ADDENDUM NO. 1

REQUEST FOR QUOTATIONS (RFQ) NO.: 1220-050-2015-013
TITLE: ARTISTIC USE OF CITY SPACE
ADDENDUM ISSUE DATE: JUNE 10, 2015
CLOSING DATE: PREFER TO RECEIVE QUOTATIONS ON OR BEFORE JUNE 11, 2015

Surrey Arts Workshop

Sk 02 Scope of Work Plan

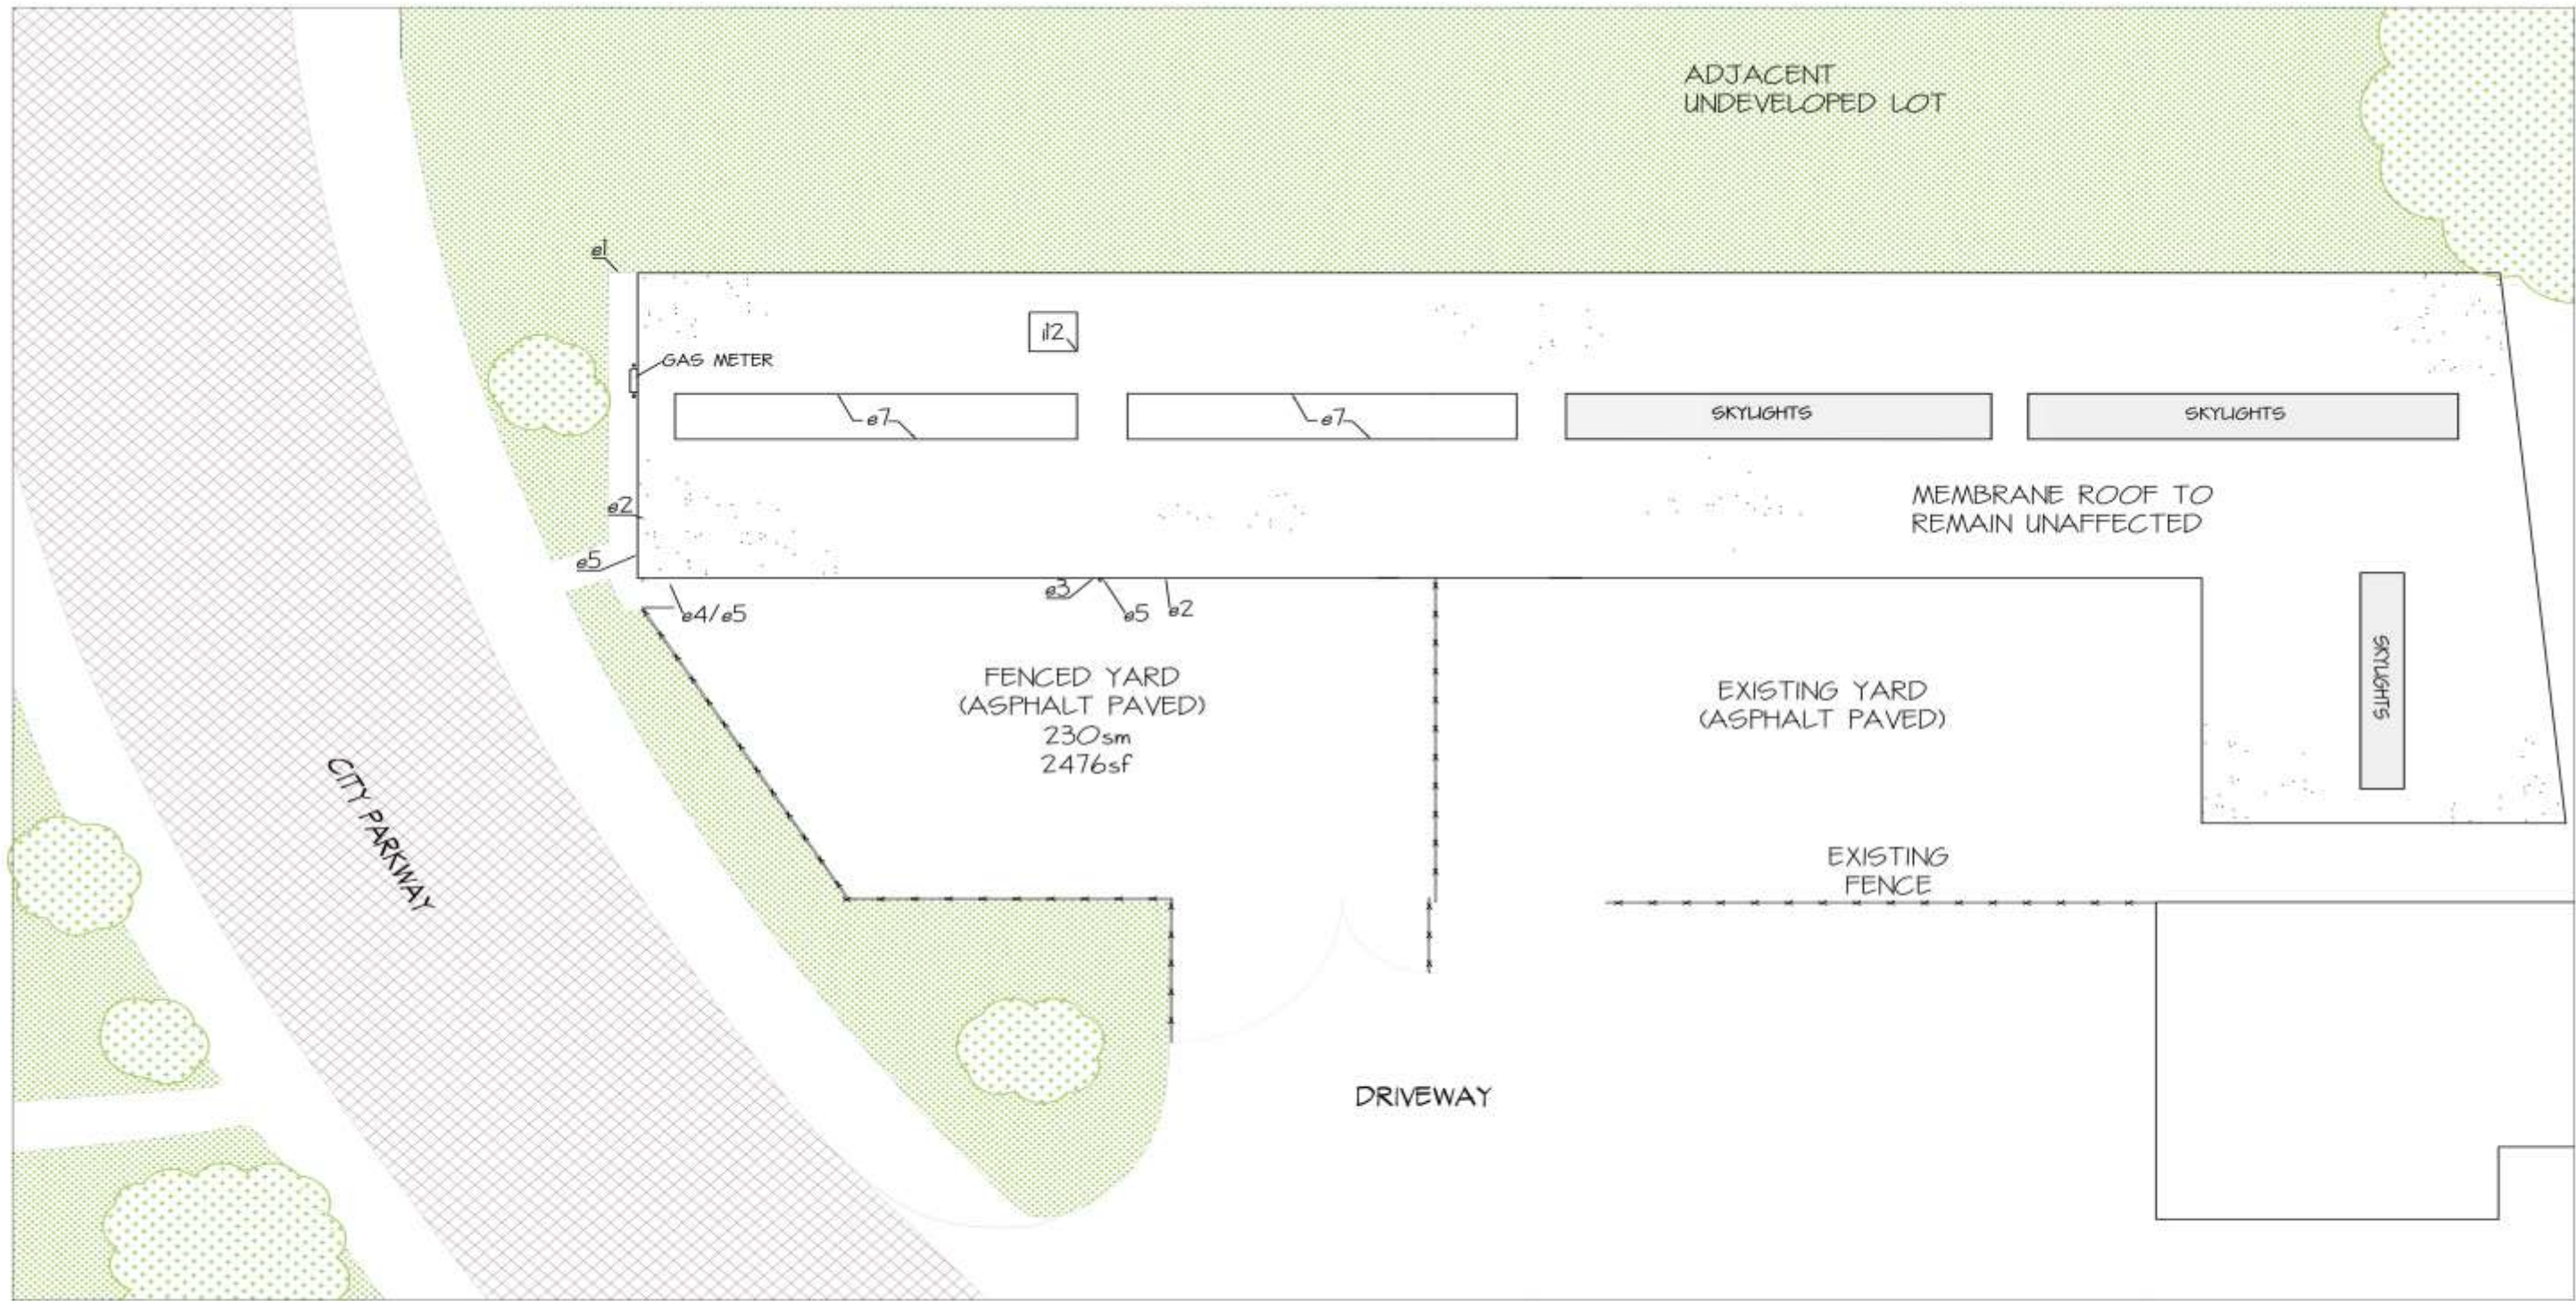
Q.1. Is the City able to provide a copy of the existing building floor plans for the site?

A.1. Please see attached report. The data and information in the attached report is for information purposes only and should not be considered to be the City's final plans for the site.
